Model: AP-C3		Date: 04-Mar-13	No.: RD144069
Subject: Parts change information.		Prepared by: H. Tamaki	
From: 1st Tech Service Sect., MFP/P Tech Service Dept.			
Classification:	<input type="checkbox"/> Troubleshooting	<input checked="" type="checkbox"/> Part information	<input type="checkbox"/> Action required
	<input type="checkbox"/> Mechanical	<input type="checkbox"/> Electrical	<input type="checkbox"/> Service manual revision
	<input type="checkbox"/> Paper path	<input type="checkbox"/> Transmit/receive	<input type="checkbox"/> Retrofit information
	<input type="checkbox"/> Product Safety	<input type="checkbox"/> Other ()	<input type="checkbox"/> Tier 2

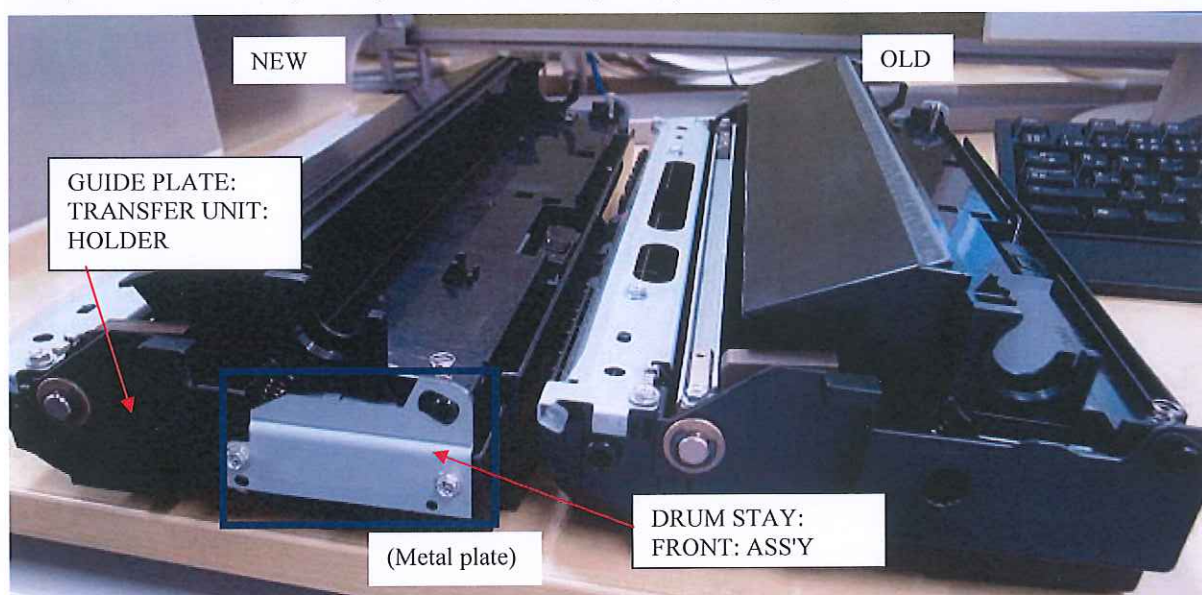
Old part number	New part number	Description	Q'ty	Int	Page	Index	Note
D1446286	D1446274	CASE:TRANSFER ROLLER	1	X/X	-	-	
D0894663	D0894664	GUIDE PLATE:TRANSFER UNIT:HOLDER	1	X/X			
	D0894665	SHAFT:HOLDER:REAR	1	X/X	-	-	-
	04583010N	HEXAGON HEAD TAPPING SCREW:3X10	1	X/X	-	-	-
	D0894666	DRUM STAY:FRONT	1	X/X	-	-	-
	04583008N	HEXAGON HEAD TAPPING SCREW:3X8	2	X/X	-	-	-

Change: The material of the parts was changed from a resin to a metal.

Reason: To further increase the load-bearing strength of the parts.

Important: Interchangeability is **X/O** as a set (all six parts together).
